Technical Service Bulletin: tsb100216

Introduction of New Fuel Filter Head Outlet Fitting with Check Valve for QSK45, QSK60, and QSK78 Engines

This Technical Service Bulletin introduces a new fuel filter head outlet fitting with an internal check valve, Part Number 4086602, for QSK45, QSK60, and QSK78 engines.

05600156

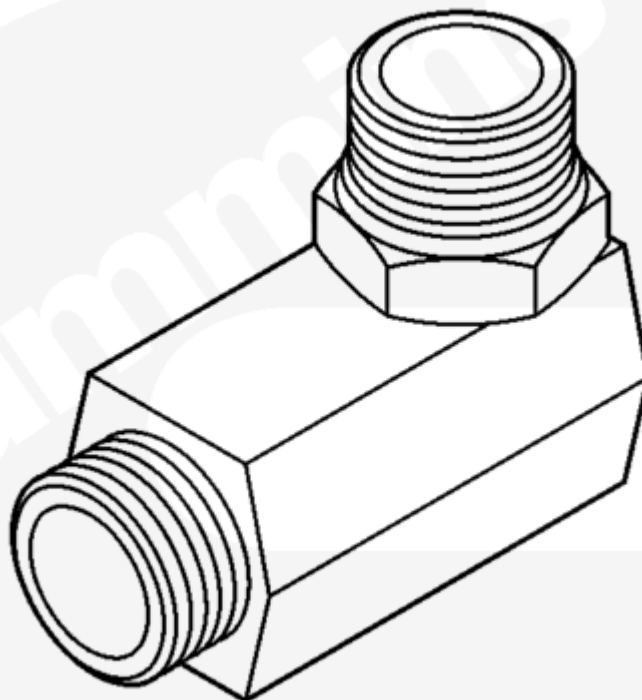
The new fuel filter head outlet fitting with an internal check valve can **only** be used with the new number 20 SAE size fuel line and the corresponding fuel pump inlet connection.

The hard starting failure mode is associated with the current fuel filter head outlet fitting. This is due to fuel in the fuel line draining back into the fuel filters. When this occurs, the engine will experience a hard starting condition. The check valve holds the fuel in the fuel line between the fuel filter head and the fuel pump.

The old fuel filter head outlet fitting, Part Number 3332349, is now being obsoleted and superseded to the new fuel filter head outlet fitting. The new fuel filter head outlet fitting with internal check valve was made an option for production at the Daventry Engine Plant in January 2003.

Description	Part Number
Valve, check	4086602
Hose, flexible	4007058
Elbow, male adapter	4007074
